FORMER CENTRAL RETAIL PARK
ROCHDALE
DESIGN & ACCESS STATEMENT
ADDENDUM

ORRD-LRW-XX-XX-PP-A-00624_P03 | JULY 2024

This Design and Access Statement Addendum has been prepared by Leach Rhodes Walker for Wilmott Dixon and Rochdale Development Agency in support of the non material amendment to the currently consented residential development in Rochdale approval reference:22/01119/FUL.

Roof Floor Plan

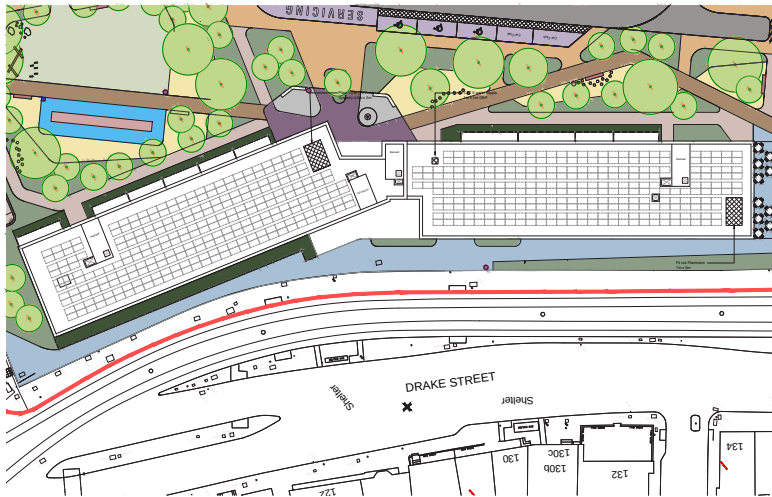
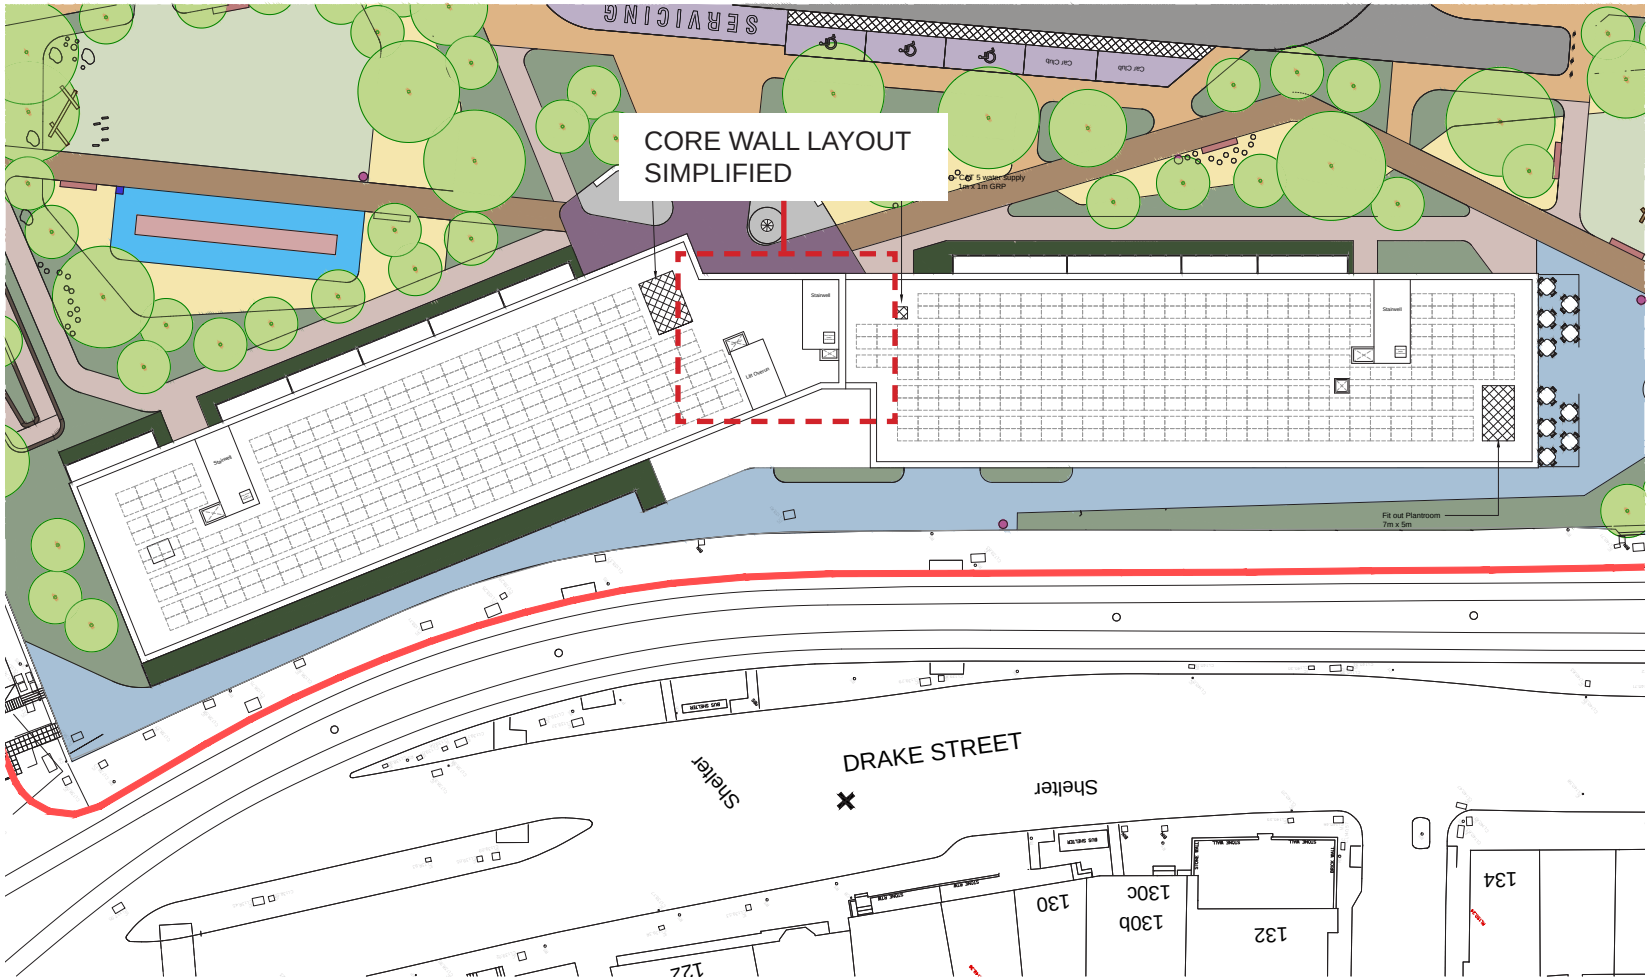
On the roof floor the walls around the central core have been simplified to improve buildability.

West Elevation

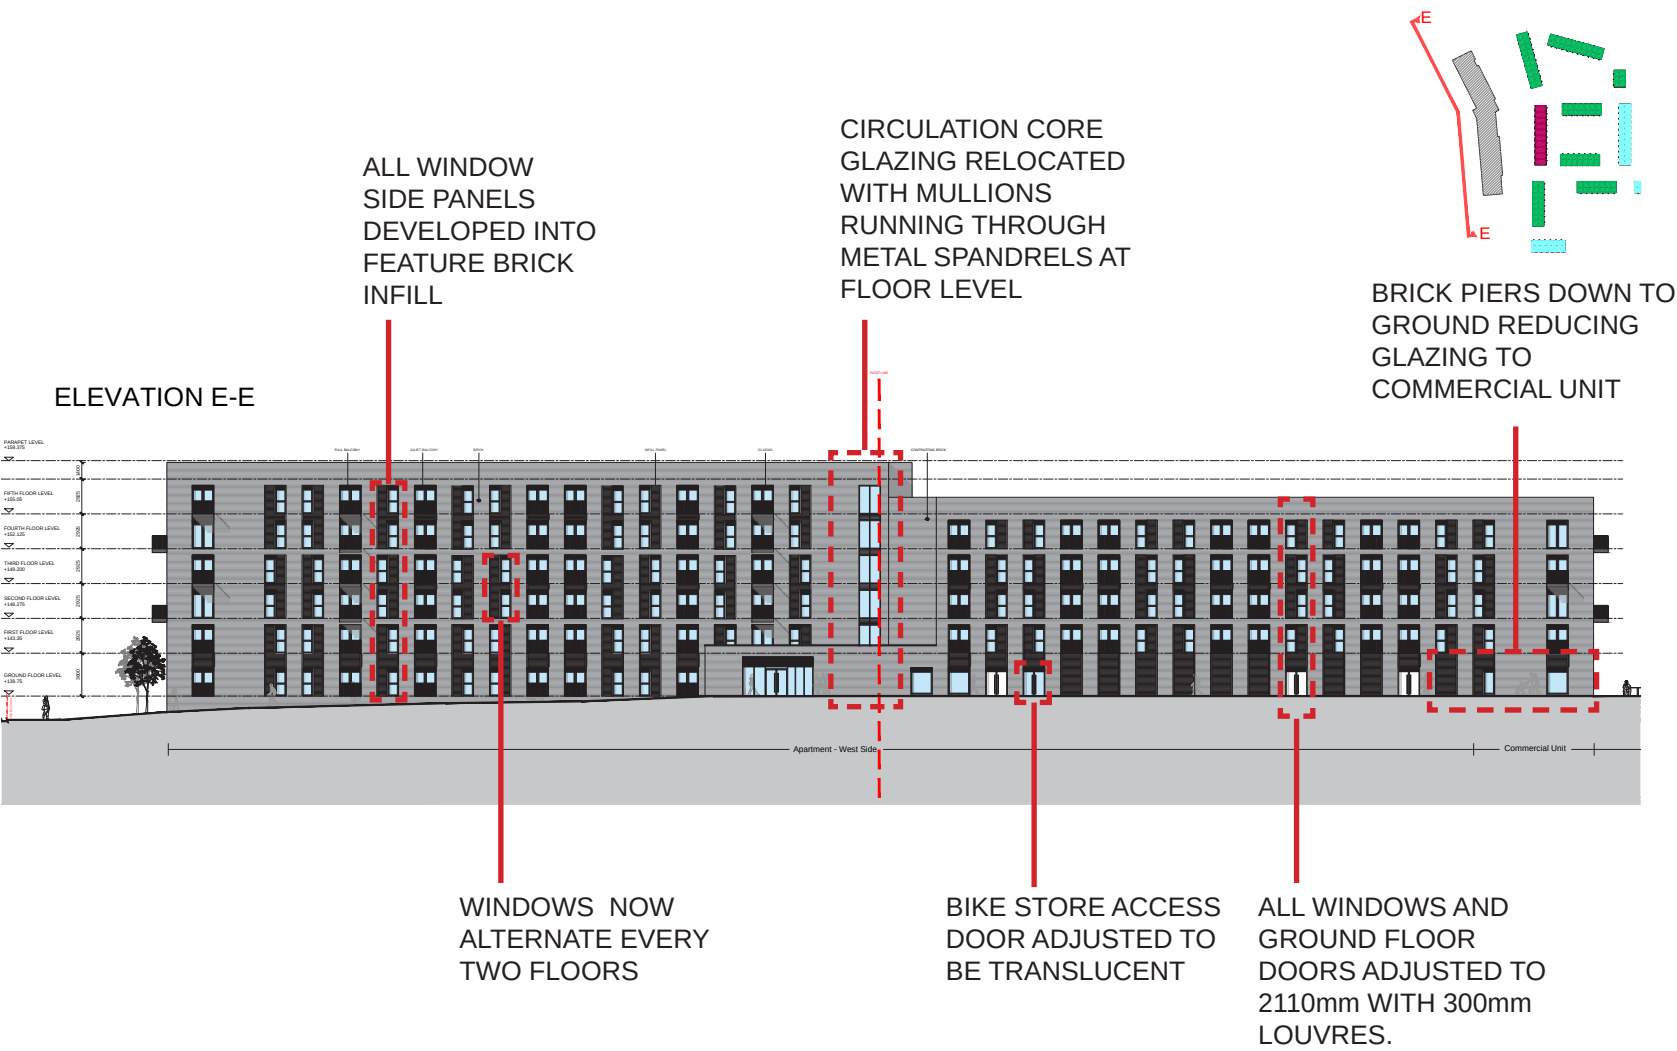
On the west elevation the windows have been amended so they only alternate every two floors, as well as this the window side panels have been developed into feature brick infills with a 10mm recess every other course. With the simplification of the core circulation area the amount of glazing has been reduced and relocated with the mullions running through the metal spandrels at every floor level. The brick piers come down to ground on the south end of the building reducing the glazing for the commercial unit. This improves the flexibility of the space to adapt the commercial unit into an additional residential unit in future. All the window and ground floor door heights reduced to 2100mm with 300mm louvres.

East Elevation

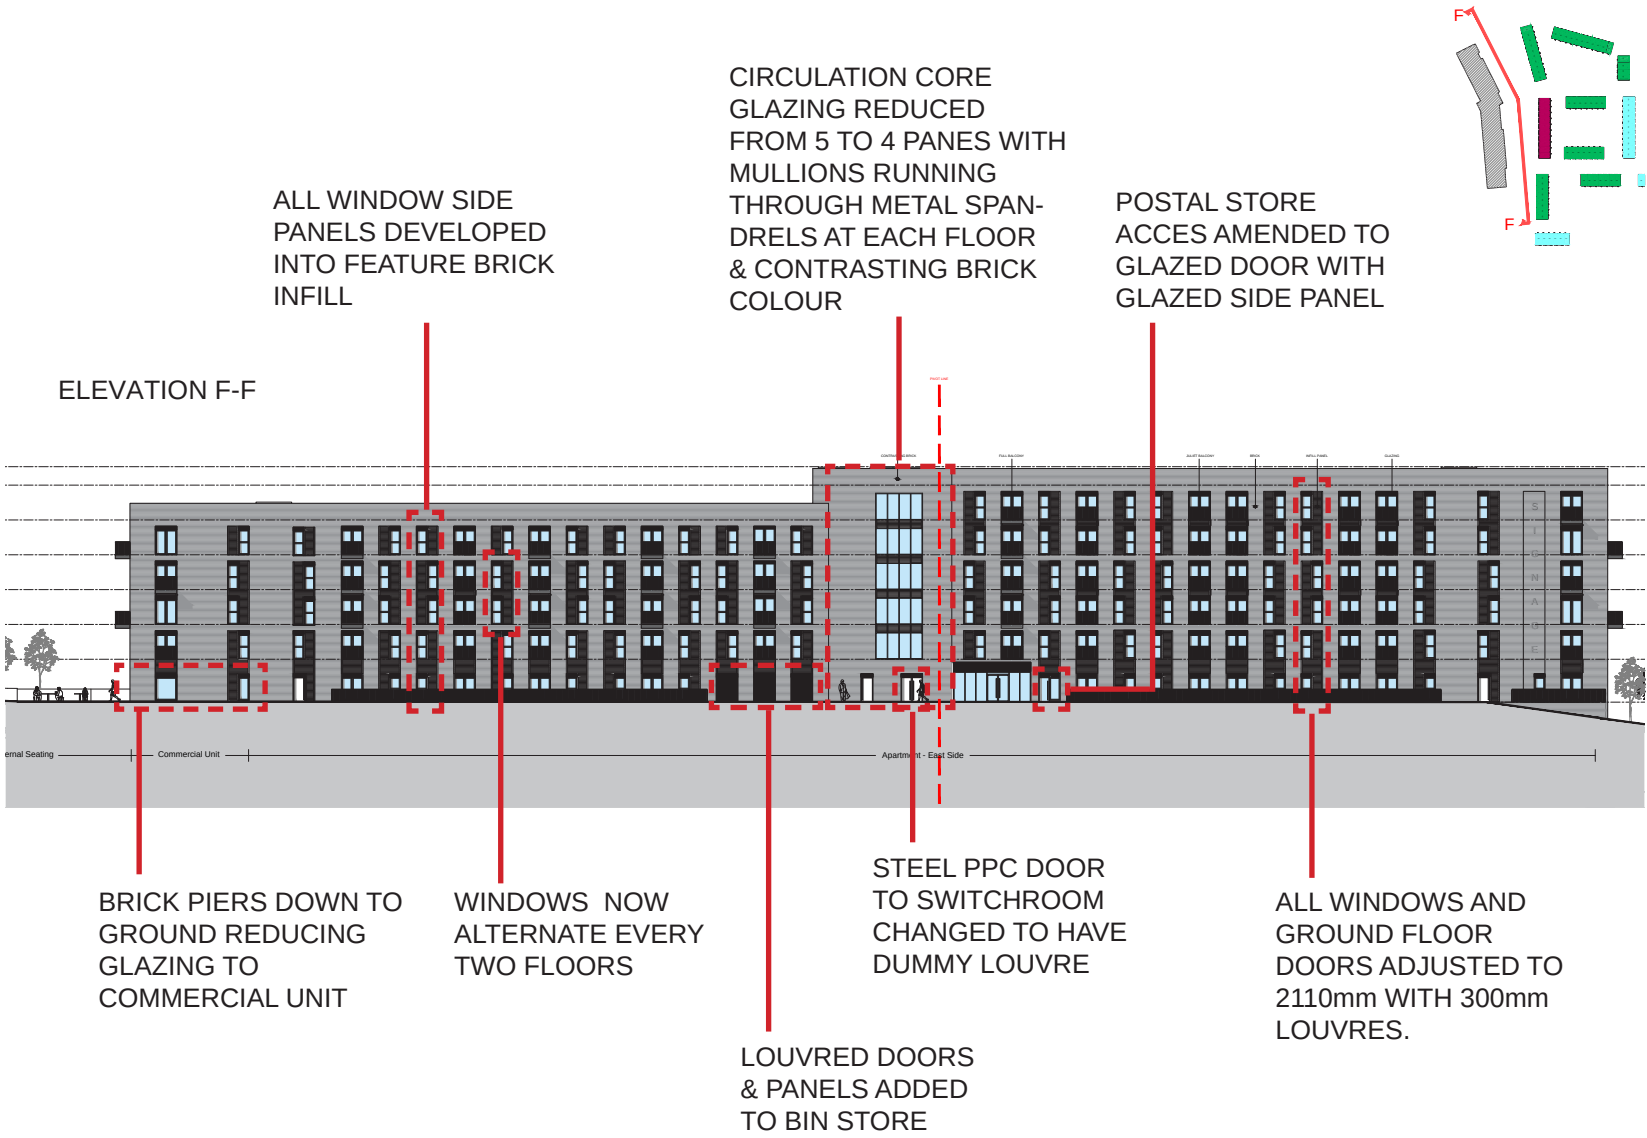
On the east elevation the windows have been amended so they only alternate every two floors, as well as this the window side panels were developed into feature brick infills with a 10mm recess every other course. With the simplification of the core circulation area the amount of glazing has been reduced from 5 to 4 panes with the mullions running through the metal spandrels at every floor level. The stepped in area of the circulation area has been developed to be a contrasting brick colour to match the feature brick panels. Brick piers come down to ground on the south end of the building reducing the glazing to improve the flexibility of the space with the ability to adapt the commercial unit into an additional residential unit in future. All the window heights reduced to 2100mm with 300mm louvres. At ground amendments have been made to the access doors for the parcel store, bin store and switchroom.

South Elevation

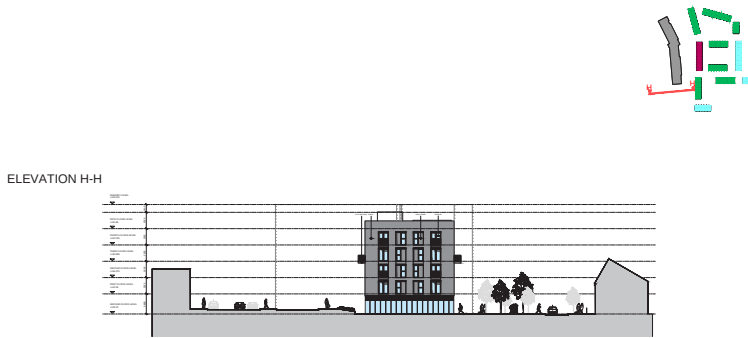
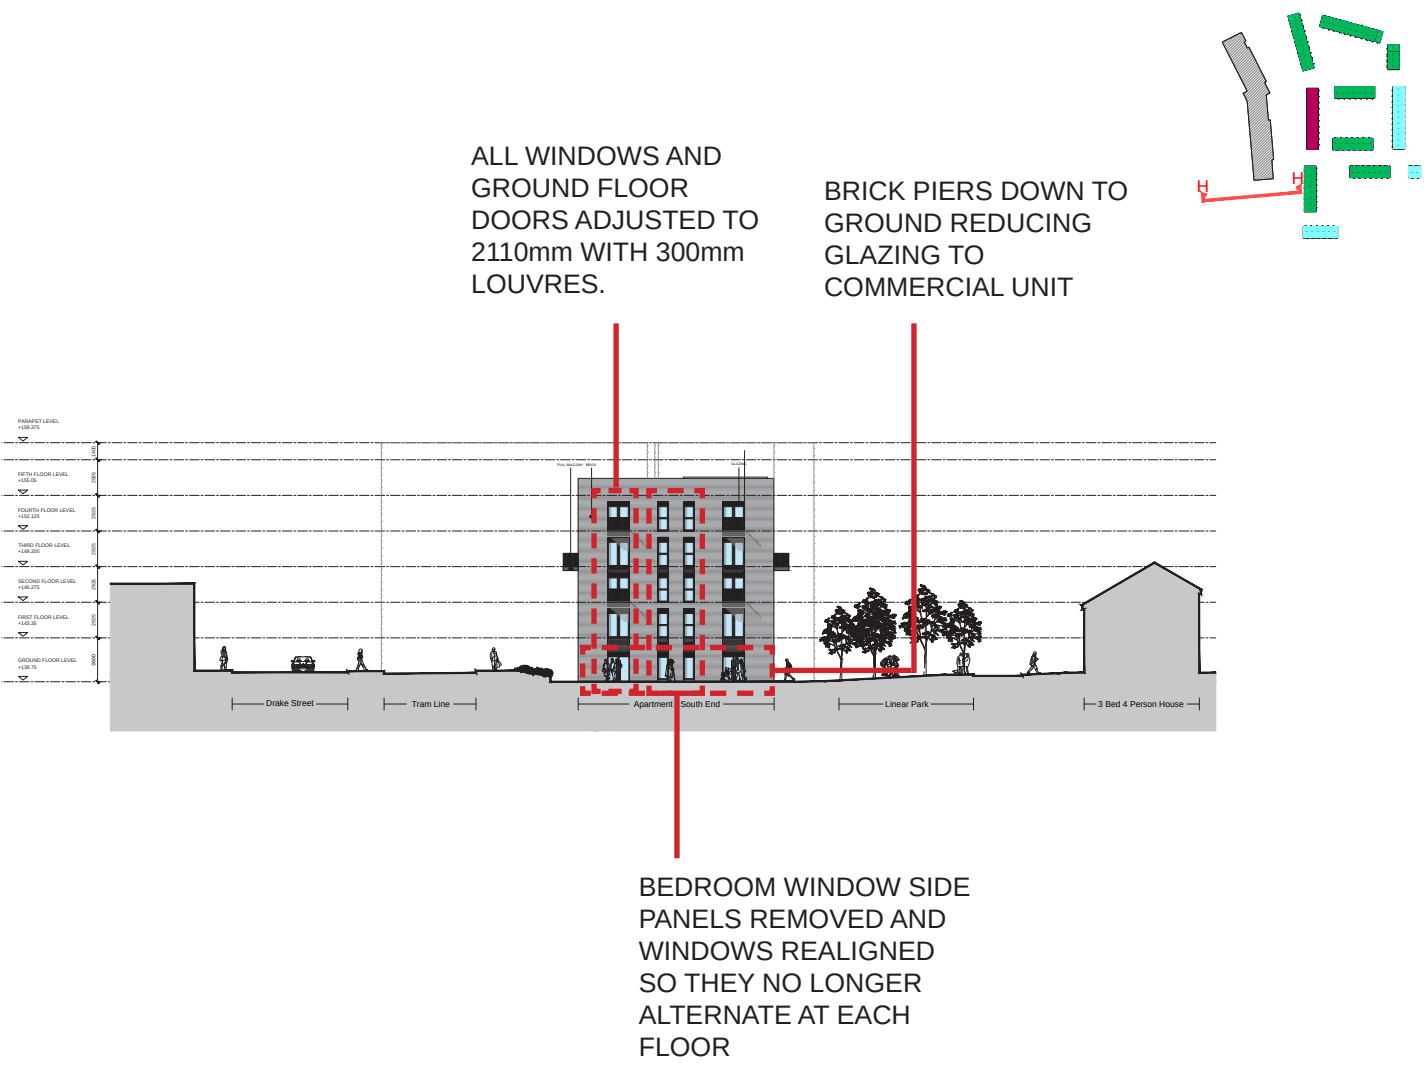
On the south elevation the side panels adjacent to the bedrooms windows have been removed and realigned so they no longer alternate at each floor simplifying the design. All the window heights reduced to 2100mm with 300mm louvres. Brick piers come down to ground on the south end of the building reducing the glazing to improve the flexibility of the space with the ability to adapt the commercial unit into an additional residential unit in future.
